**HISTORIC LANDMARK COMMISSION**  
**APPLICATION FOR A CERTIFICATE OF APPROPRIATENESS**  
**NOVEMBER 2, 2022**  
**HR-2022-119336**  
**CASTLE HILL**  
**900 BLANCO-1202 W. 9<sup>TH</sup> ST, & 901 SHELLEY AVE**

Demolition, addition, and alteration of two contributing circa 1910 structures on one lot

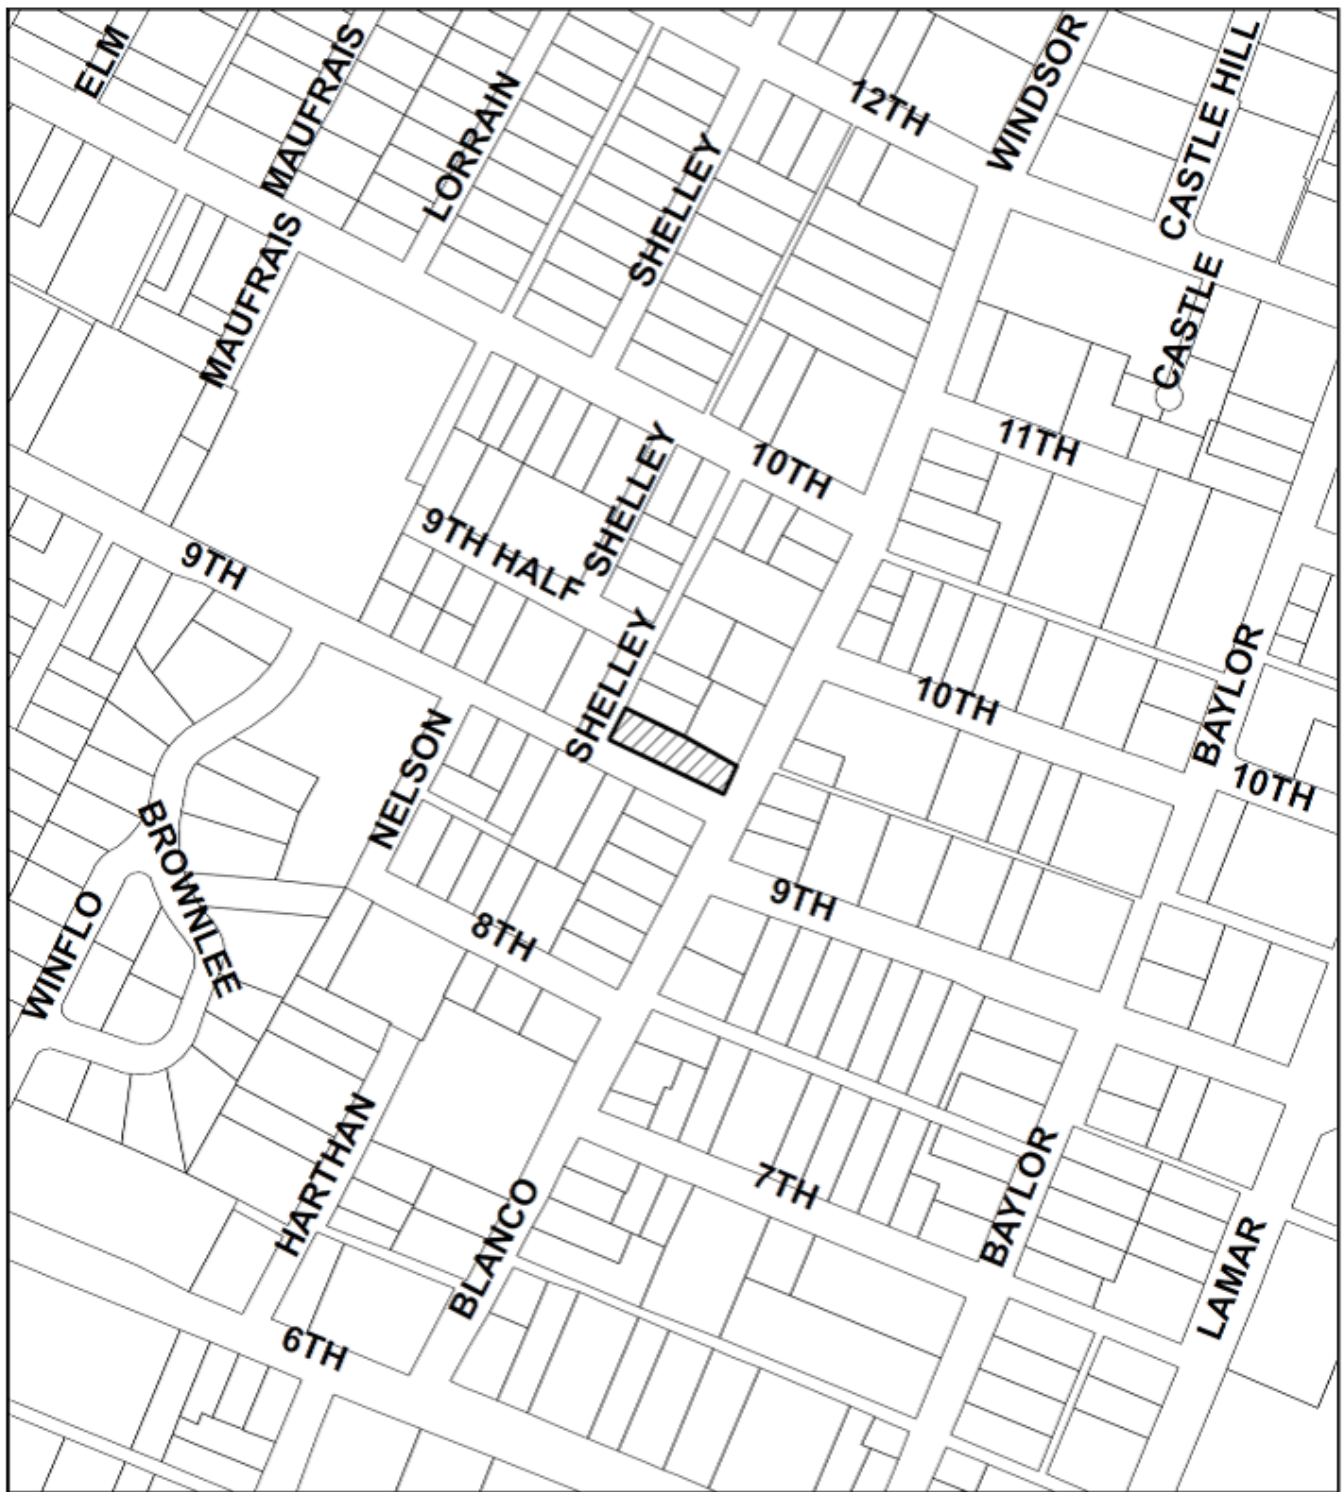
The ARC was generally pleased with the new design and commented that the rotation of the Carriage house presented an unusual solution to an unusual property and made a handsome addition to the Shelly streetscape. The ARC did explain that they were opposed to deconstruction and that only a 'lift-and-rotate' method of moving the carriage house was approved. Furthermore, if any further demolition is needed than what the plans call for due to deterioration, for example, the project should return to the HLC. The ARC recommended that the method of moving to be included in plans and that any replacement windows in the Carriage House be 1:1.

Staff recommends approval of the plans with the following conditions: notes are added to the plans that the carriage house is moved under structural engineer supervision via lifting and rotating the structure, not deconstruction and rebuild; and if there is significant deterioration found resulting in the need for deviance from the approved plans that the case return to the Historic Landmark Commission for approval.
